TRANSMITTAL FOR POWER OF ATTORNEY TO ONE OR MORE REGISTERED PRACTITIONERS

Application Number	
Filing Date	02-Oct-2014
First Named Inventor	Peter John COUSINS
Title	FRONT CONTACT SOLAR CELL WITH FORMED EMITTER
Art Unit	
Examiner Name	
Attorney Docket Number	10031.004211

FIG. 3D

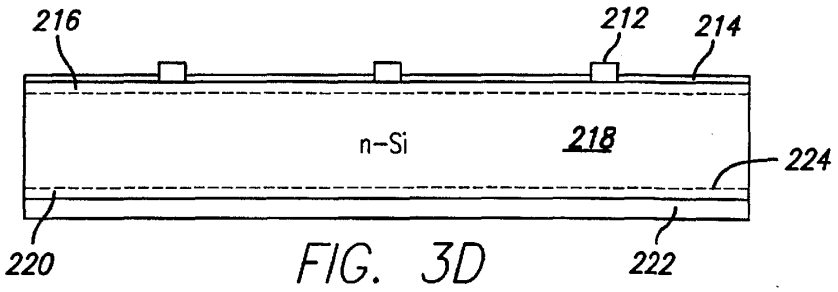
The final office action suggests that in the cited combination, Meier discloses the recited backside junction. Meier FIG. 3D is reproduced below for ease of discussion.

Meier discloses a solar cell with an aluminum alloy back junction (Meier, Title). More specifically, Meier discloses forming a p+ layer 220 ("emitter") that forms a backside junction with the n-Si base layer 218 ("substrate") within the base layer 218 by doping using the aluminum contact layer 222 (Meier, col. 6, lines 51-54). That is, the main

FIG. 3D

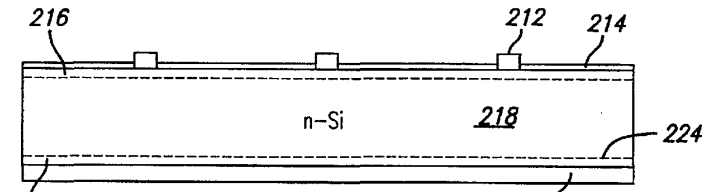
The final office action suggests that in the cited combination, Meier discloses the recited backside junction. Meier FIG. 3D is reproduced below for ease of discussion.

Meier discloses a solar cell with an aluminum alloy back junction (Meier, Title). More specifically, Meier discloses forming a p+ layer 220 ("emitter") that forms a backside junction with the n-Si base layer 218 ("substrate") within the base layer 218 by doping using the aluminum contact layer 222 (Meier, col. 6, lines 51-54). That is, the primary teaching of Meier is to form an aluminum alloy back junction by forming the p+ layer 220 within the substrate by diffusion into the substrate using the aluminum alloy electrode, thereby providing a strongly doped p-type emitter (Meier, abstract).

FIG. 3D

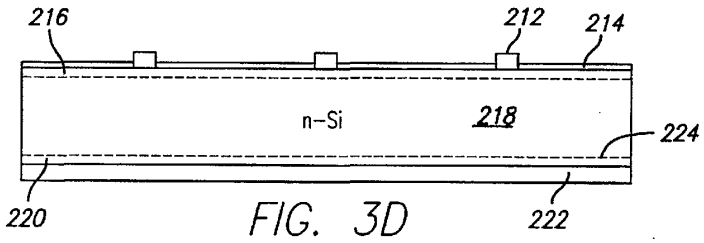
The final office action suggests that in the cited combination, Meier discloses the recited backside junction. Meier FIG. 3D is reproduced below for ease of discussion.

Meier discloses a solar cell with an aluminum alloy back junction (Meier, Title). More specifically, Meier discloses forming a p+ layer 220 that forms a backside junction with the n-Si base layer 218, within the base layer 218, by doping using the aluminum contact layer 222 (Meier, col. 6, lines 51-54). That is, the primary teaching of Meier is to form an aluminum alloy back junction by forming the p+ layer 220 by diffusion into the

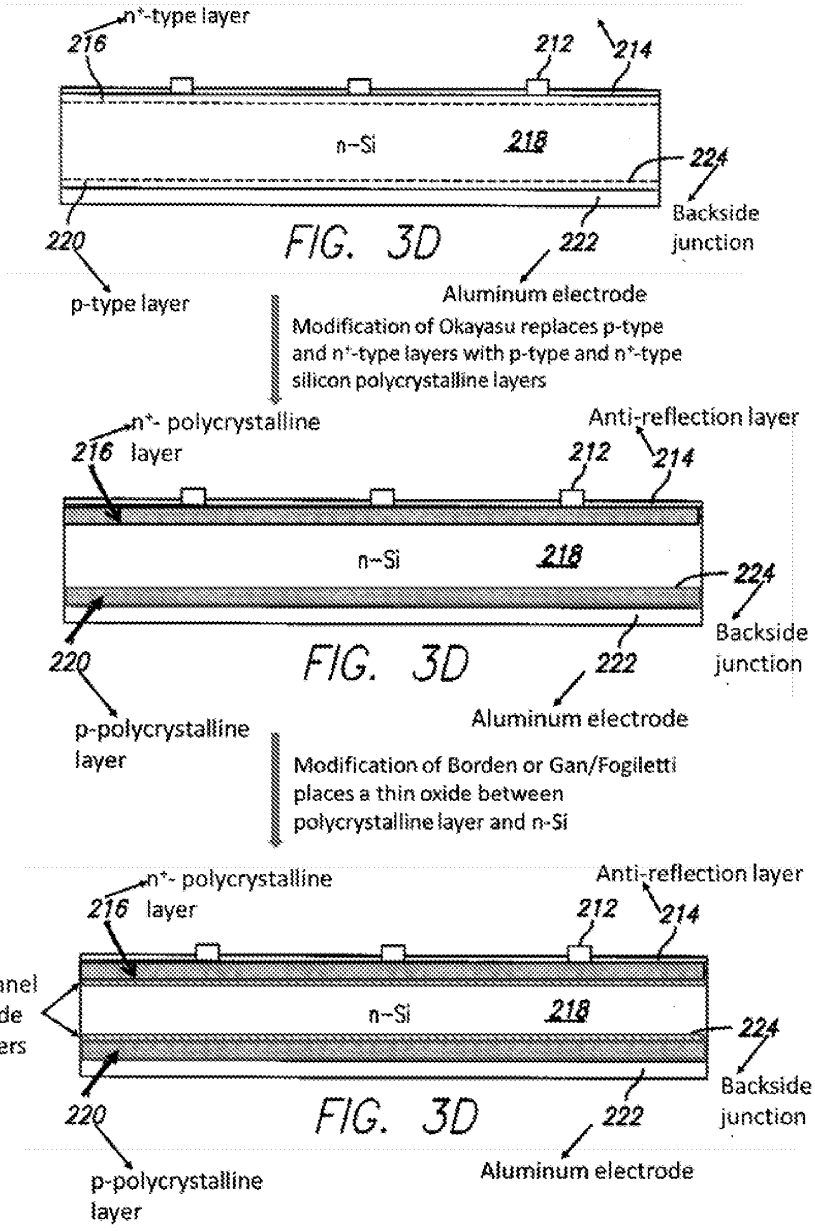
Appellant argues with respect to claim 1 that while Meier discloses a backside junction formed between the emitter (220) and base (228) Meier does not disclose the tunnel oxide between the base and emitter. Furthermore, if there were a tunnel oxide present in Meier the formation of the emitter would not be possible since it is formed from diffusion with the contact layer (222).

Appellant further argues that Okayasu discloses a BSF solar cell and that a BSF layer cannot form a backside junction with the substrate and therefore the combination of Meier and Okayasu is not possible.

FIG. 3D

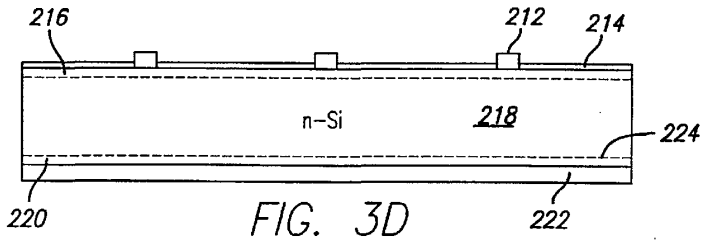
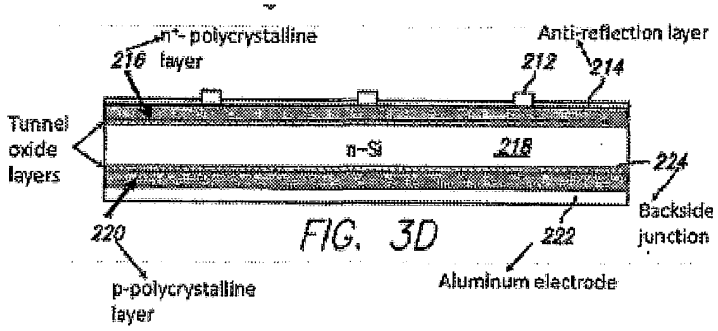
The drawing on page 10 of the Examiner's Answer shows the extent of the proposed modification to Meier. Comparing Meir's original structure,

to the modified structure,

one can see immediate major differences.

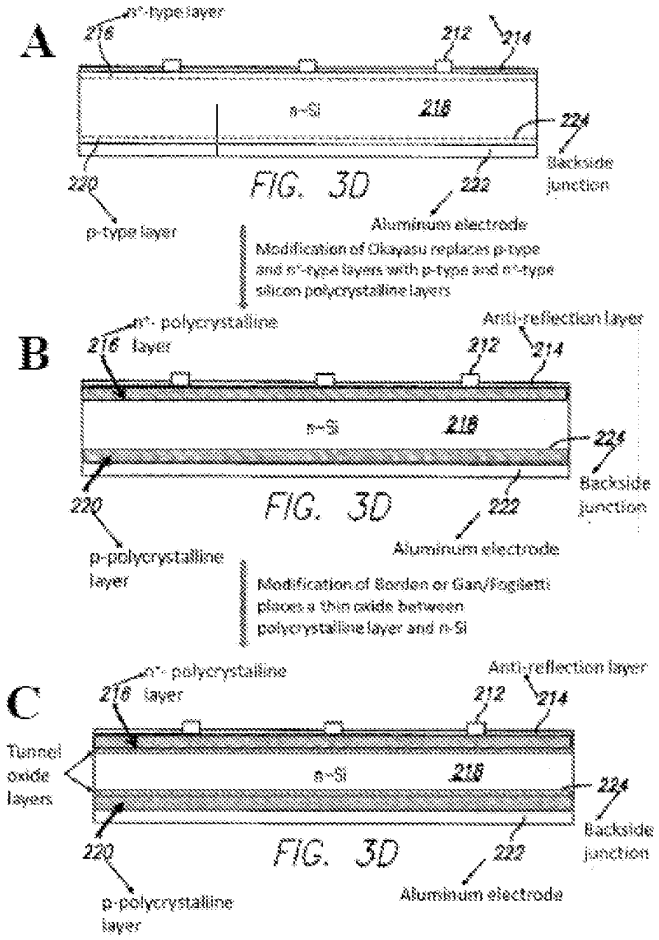
With respect to claim 1, the Examiner finds that Meier teaches the majority of the limitations. Final Act. 3. The Examiner finds that Meier teaches a method of forming a junction consisting of a p-type emitter on an n-type substrate which comprises using an aluminum electrode as a p-type dopant material and driving the dopant in through annealing. Ans. 11 (citing Meier col. 6, ll. 35–50). The Examiner further finds that Meier discloses the presence of a front surface field formed through thermal diffusion and comprised of the same type of dopant as the n-type substrate. *Id.* (citing Meier col. 5, ll. 43–49).

The Examiner finds that Okayasu discloses an alternative method for forming a doped emitter or a surface field on a dope substrate. *Id.* The Examiner finds that Okayasu teaches depositing a doped polysilicon emitter and dope surface field on a doped single crystalline substrate. *Id.* (citing Okayasu ¶¶ 14, 43). The Examiner finds that Okayasu teaches that its method of depositing doped polysilicon layers is preferable to that of thermal diffusion (as taught in Meier) because it can be performed at lower temperatures, preventing damage to the substrate, and allows more accurate control of the emitter thickness. *Id.* (citing Okayasu ¶ 8).

The Examiner concludes that one of ordinary skill in the art at the time of the invention would have found it obvious to employ Okayasu's method of forming an emitter or surface field in Meier's back junction solar cell for the advantages articulated by Okayasu. *Id.* at 12.
